ADDRESS: 2200-04 LOCUST ST

Proposal: Construct roof deck with pilot house

Review Requested: Final Approval

BACKGROUND:

Figure 1: Aerial view looking west at roof of 2200-04 Locust Street. The blue outline shows the approximate location of the proposed roof deck and pilot house.

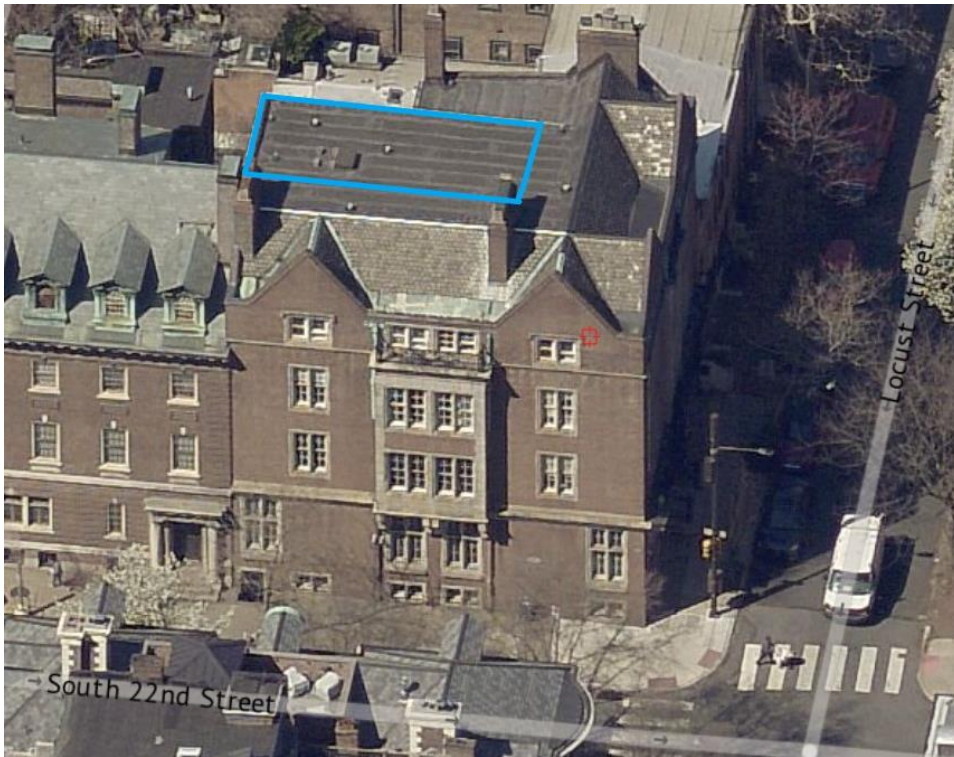
- The proposed roof addition could meet the Roofs Guideline if the pilot house was lowered in height by one to two feet. The roof mockup shows the flag visible 12 feet above the roof deck from viewpoints looking toward primary facades along Locust and S. 22nd Streets. The height of the pilot house is currently proposed to be 10 feet. If the pilot house is reduced in height by one to two feet, it will be inconspicuous from the public right-of-way along Locust Street and S. 22nd Street.

- The proposed roof deck and railing could meet the Roofs Guideline if they are moved back five feet from the Locust Street (east) and S. 22nd Street (north) elevations. With this additional setback, the railing will be inconspicuous from the public right-of-way along Locust Street and S. 22nd Street.

- Elements of the roof deck structure and railing on the west elevation may be visible from the east further down Locust Street, but they will likely be inconspicuous from the public right-of-way.

STAFF RECOMMENDATION: Approval, provided the height of the pilot house is reduced and roof deck is set back further along Locust Street and S 22nd Street, pursuant to Standard 10 and the Roofs Guideline.
